## Department of Transportation

### MEMORANDUM

**SUBJECT:** ZC Case No. 18-14 – 3836-3848 South Capitol Street SE

Figure 1 – Site Plan (Source: Gorove/Slade, 1/29/19 CTR, Figure 9)

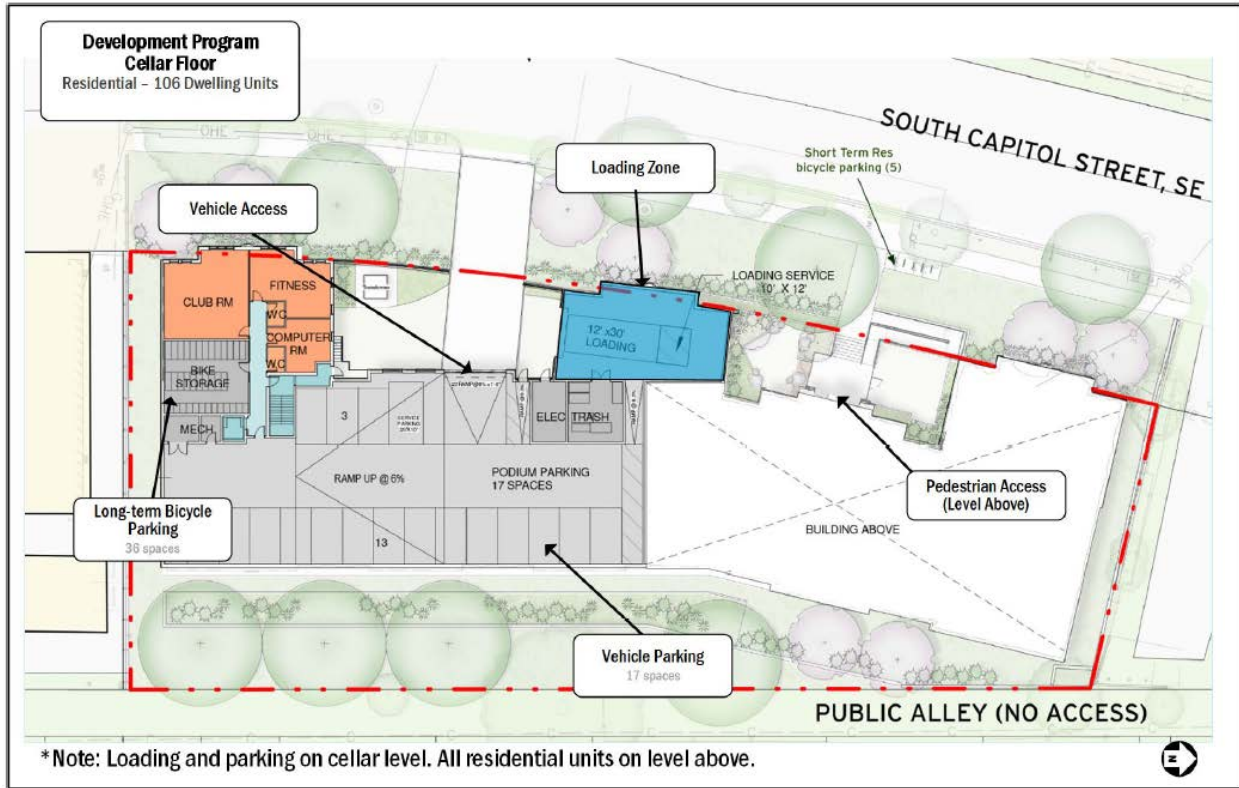
Site access is proposed via an unsignalized driveway to South Capitol Street SE opposite Xenia Street SW. As part of scoping the CTR, DDOT requested the Applicant evaluate this access scheme, as well as other schemes such as re-use of the existing curb cut further to the north and constructing a portion of the public alley to provide access via the rear of the site. Gorove/Slade provided an Access Evaluation Memorandum, dated February 20, 2019, which supports the proposal for an unsignalized intersection in this location.

DDOT's first preference for access was via the rear public alley. Given the significant grade challenges at the rear of the property, it was not feasible to construct a portion of the unbuilt 'paper alley.' In order to consolidate and minimize the turn conflicts along South Capitol Street SE, it was determined that providing the access opposite Xenia Street SW where the site's driveway can form the fourth leg of a complete intersection would be the next best access scenario. Given the low volumes expected to utilize this leg of the intersection (14 in the AM peak hour, 17 in the PM peak hour) a traffic signal is not warranted. Since the driveway is located on a curve, DDOT also required the Applicant to provide a sight distance evaluation. The analysis indicated that the site driveway meets the AASHTO "Green Book" standards for sight distances for vehicles turning left and right out of the site.

The Applicant is currently pursuing a public space application for 'conceptual approval' from the Public Space Committee (PSC) for the curb cut on South Capitol Street SE. The TOPS tracking number is #324942. While the site access point has not yet been approved by the PSC, DDOT will support the Applicant's proposed access scheme as part of the public space permit application, so long as signage is installed south of the site on the northbound approach of South Capitol Street SE indicating to motorists that an intersection is ahead.

Aside from determining the final location of the newly proposed curb cut on S. Capitol Street SE, as discussed in the Site Access section above, the Applicant must work with DDOT and OP to address the following public space issues:

- All building entrances must be at-grade with no ramps or stairs in public space. If ramps or stairs are necessary, they must be constructed on private property;
- Close all existing curb cuts to the property;
- The leadwalk should be reduced to 6-feet wide to minimize paving in public space;
- Determine final location for the short-term bicycle racks; and
- Existing bus stop should be designed into the final public space design in its current location. Bus stop will need to be accommodated during construction.

- Install signage on the northbound South Capitol Street SE approach to the site driveway indicating that there is an intersection ahead. Signage is subject to DDOT approval;
- Implement the Loading Management Plan (LMP), as proposed by the Applicant in the January 29, 2019 CTR; and
- Implement the Transportation Demand Management (TDM) plan proposed in the Applicant's January 29, 2019 CTR, with the following minor additions:
  - Work with DDOT and goDCgo (DDOT's TDM program) to implement TDM measures at the site;
  - Share the full contact information of the TDM Leaders for the site with DDOT and goDCgo ([info@godcgo.com](mailto:info@godcgo.com));
  - Post all TDM commitments online for easy reference; and
  - Provide annual Capital Bikeshare memberships to each resident for the first year after the building opens.
